Access Compliance Report

Public Rights-of-Way

(Pedestrian Signals)

Intersection ID: N/A	Main Street:	Cross Street: N/A	Location: N/A
ADA ID: A3DD092823D4	Signal Type: One Push Button-Non APS	Overall Compliance: No	Severity Score: BTN 1: N/A BTN 2: N/A No BTN: N/A
Codes/Mitigation Info/Possible Solution		Field Measurements/Component Compliance

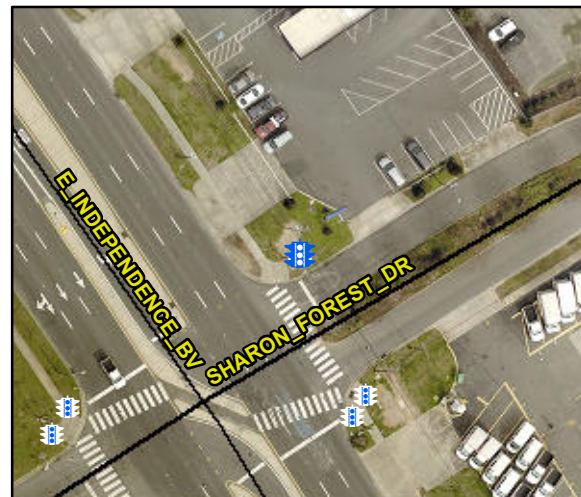
Compliance	Description	Data	Compliance	Description	Data
	Button Count	Button1	N/A	Distant to Additional Button (in)	N/A
	Additional Button Present?	No		Additional Button ID	N/A
N/A	Signal Buttons Required?	N/A	N/A	Additional Ped Posts Required	N/A
	How Many Ped Street Xings?	1		Located In An Island/Median?	No
N/A	B 1 Sign Present?	Yes	N/A	B 2 Sign Present?	N/A
Yes	B 1 Sign Purpose?	Yes	N/A	B 2 Sign Purpose?	N/A
Yes	B 1 Sign Lettering & Contrast?	Yes	N/A	B 2 Sign Lettering & Contrast?	N/A
Yes	B 1 Parallel To XWalk?	Yes	N/A	B 2 Parallel To XWalk?	N/A
Yes	B 1 PAR to Button?	Yes	N/A	B 2 PAR to Button?	N/A
Yes	B 1 PAR to XWalk?	Yes	N/A	B 2 PAR to XWalk?	N/A
Yes	B 1 Clear Floor Space?	Yes	N/A	B 2 Clear Floor Space?	N/A
N/A	B 1 FWD Approach?	Yes	N/A	B 2 FWD Approach?	N/A
N/A	B 1 FWD Approach Constrained?	No	N/A	B 2 FWD Approach Constrained?	N/A
No	B 1 FWD Approach Reach (in)	6.0	N/A	B 2 FWD Approach Reach (in)	N/A

N/A	B 1 FWD Approach Width (in)	N/A	N/A	B 2 FWD Approach Width (in)	N/A
N/A	B 1 FWD Approach Obstruction?	Yes	N/A	B 2 FWD Approach Obstruction?	N/A
N/A	B 1 FWD Approach Obstruction Dist (in)	4.0	N/A	B 2 FWD Approach ObstructionDist (in)	N/A
N/A	B 1 PARA Approach?	Yes	N/A	B 2 PARA Approach?	N/A
N/A	B 1 PARA Approach Constrained?	No	N/A	B 2 PARA Approach Constrained?	N/A
Yes	B 1 PARA Approach Reach (in)	6.0	N/A	B 2 PARA Approach Reach (in)	N/A
N/A	B 1 PARA Approach Width (in)	N/A	N/A	B 2 PARA Approach Width (in)	N/A
N/A	B 1 PARA Approach Obstruction?	Yes	N/A	B 2 PARA Approach Obstruction?	N/A
N/A	B 1 PARA Approach Obstruction Dist (in)	4.0	N/A	B 2 PARA Approach ObstructionDist (in)	N/A
Yes	B 1 Clear Floor Space Slope (%)	2.3	N/A	B 2 Clear Floor Space Slope (%)	N/A
No	B 1 Clear Floor Space XSlope (%)	3.5	N/A	B 2 Clear Floor Space XSlope (%)	N/A
N/A	B 1 PAR Slope (%)	4.5	N/A	B 2 PAR Slope (%)	N/A
Yes	B 1 Height (in)	38.0	N/A	B 2 Height (in)	N/A

Yes	B 1 Clear Xing Direction?	ClearlyMarked	N/A	B 2 Clear Xing Direction?	N/A
	B 1 Crossing Direction	To SE		B 2 Crossing Direction	N/A
No	B 1 DistanceTo XWalk (in)	95.0	N/A	B 2 DistanceTo XWalk (in)	N/A
No	B 1 DistanceTo Curb (in)	73.0	N/A	B 2 DistanceTo Curb (in)	N/A
Yes	B 1 Diameter (in)	2.0	N/A	B 2 Diameter (in)	N/A

Possible Solutions: Replace Signal Push Button With APS Button on New Post. Remove & Relocate Sign.
